SUNDRY NOTICES AND REPORTS ON WELLS

| 12. CHECK APPROPRIATE BOX(es) TO INDICATE NATURE OF NOTICE, REPORT, OR OTHER DATA | 9. API Well No. <u>30-045-10383</u> |

**Plugging and Abandonment Procedure
Horseshoe Gallup Unit No. 7
Attachment "A"**

CONDITIONS OF APPROVAL

WELL NAME 7 HGU
 SEC, TWN, RNG. 30-31N-16W

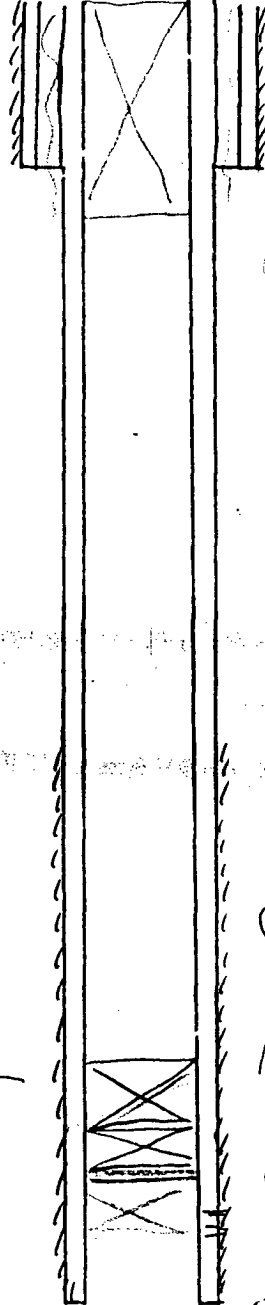
a) Bring the top of the Gallup plug to 1128'.

b) Place the Surface plug from 184' to surface inside and outside the 5 ½" casing.

You are also required to place cement excesses per 4.4 of the attached General Requirements.

- BLM geologist's pick for the top of the Gallup fm. reflects the top of the transitional Tocito interval in this well. This top varies from operator's pick in this well.
- Potential useable water sands in the Point Lookout fm. are behind S.C.
- It is recommended that the Gallup plug be extended upward to adequately isolate the Gallup top identified in this report.

Plu 184 - surface =
 $184 / 7.299 (1.18) = 21 \text{ SKS}$
 $50 / 5.7719 (1.18) = 7 \text{ SKS}$
 $134 / 5.192 (1.18) = 22 \text{ SKS}$
 50 SKS
 =

$(1350 - 1128) + 50 / 7.299 (1.18) = 32 \text{ SKS or g.}$

Plu 1350 - 1128

retainer @ 1350' squeeze w/ 33 SKS
 Port @ 1398 - 1545
